Requirement for updating GTR15 Amendment 6 Annex 13 (Low Temperature Test Procedure)

GRPE-85-21

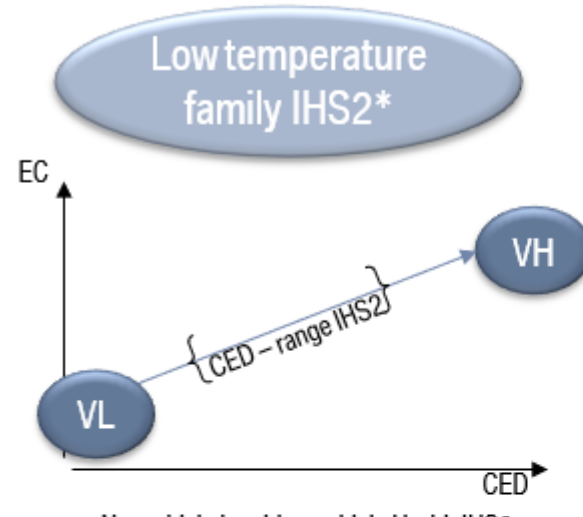
Test IHS1 vehicle configuration with either vehicle H-road load even if it does not exist but it would produce the worst case EC ratio?

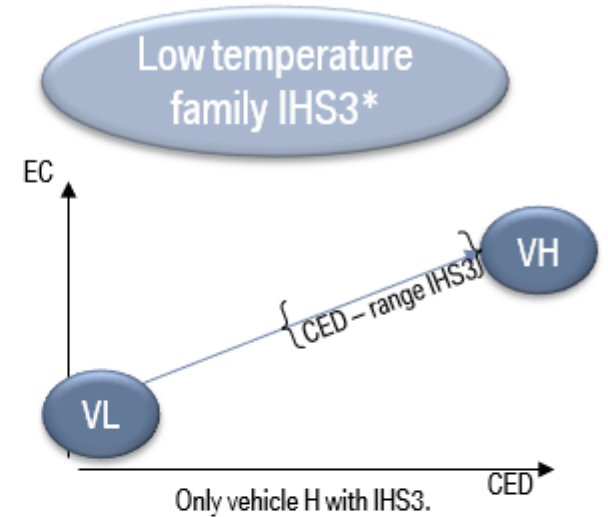
Test IHS2 vehicle configuration with either vehicle L or vehicle H road load?

Test IHS3 vehicle configuration with either vehicle L or vehicle H road load?

Current text can be misunderstood because it requires the testing of vehicle L or H of the interpolation family but this might not be equipped with the correct interior heating system.

2.6.2.3.3.2. At least one vehicle which is expected to produce the lowest ratio (i.e. combination of heater efficiency and cabin volume) for the PER ratio defined in paragraph 4.4.2.1.1. and which is expected to produce the highest EC ratio defined in paragraph 4.3.4.2.1. of sub-annex 1 shall be selected ~~from vehicle high (VH) or vehicle low (VL)~~ of the interpolation families in a Type-6 low temperature family for PEVs and tested with road loads of vehicle high (VH) or vehicle low (VL) and dyno settings adjusted as described in paragraph 2.4. of this Annex. The measured ~~EC ratio-values~~ of a tested vehicle may be extended without further testing to all family members which fulfil the family criteria defined in paragraph 5.14.2. of this UN GTR.

Image of PEV Low Temp Test and Calculation

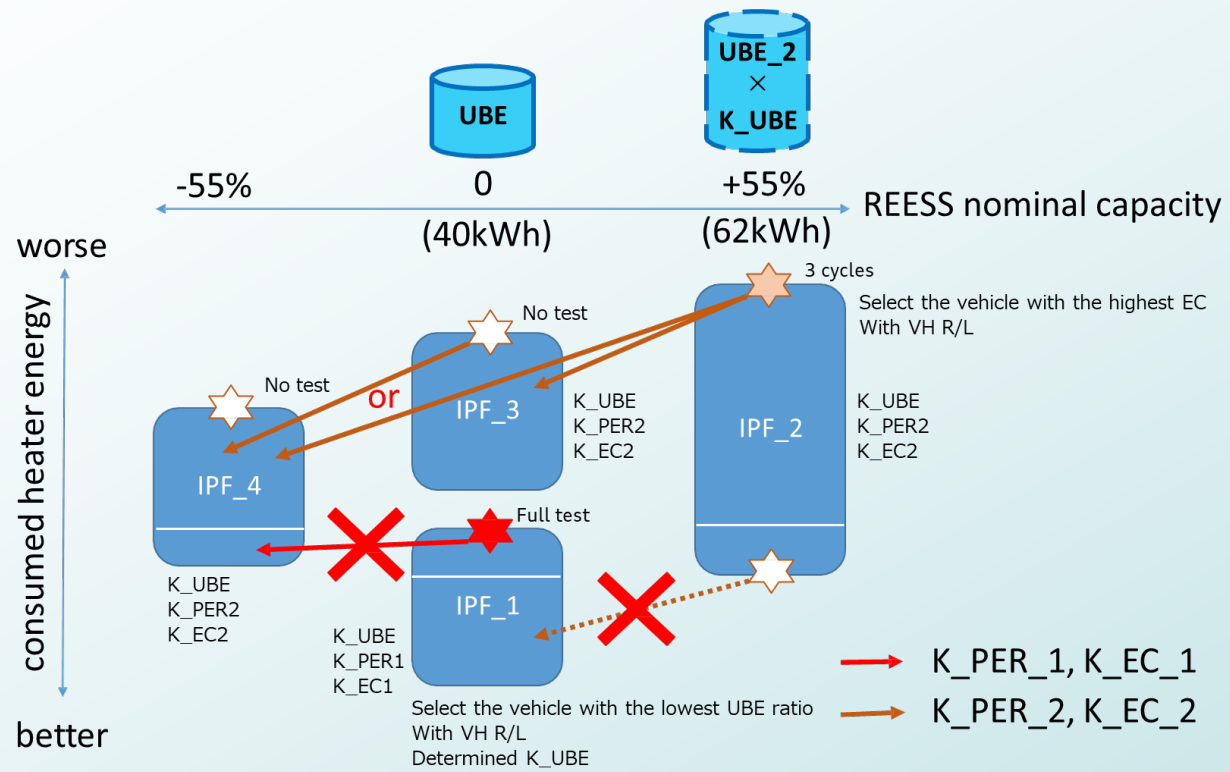
Step	Test description	Input	output	Test vehicle selection	Note
1	full ★	UBE_1 @ 23°C PER_1 @ 23°C EC_1 @ 23°C	K_{UBE} K_{PER_1}, K_{EC_1} PER/EC of V_ind in IPF_1	V_H with H_W in IPF_1	V_H for Type1 should have H_W configuration
2	3 cycles ★	UBE_2 @ 23°C, K_{UBE} PER_2 @ 23°C EC_2 @ 23°C	K_{PER_2}, K_{EC_2} PER/EC of V_ind in IPF_2	V_H with H_W in IPF_2	
3	none	PER_3 @ 23°C, K_{PER_2} EC_3 @ 23°C, , K_{EC_2}	PER/EC of V_ind in IPF_3		
4	none	UBE_4 @ 23°C, K_{UBE} PER_4 @ 23°C, K_{PER_1} EC_4 @ 23°C, K_{EC_1}	PER/EC of V_ind in IPF_4		
(5)	full or 3 cycles ★				Manufacture option
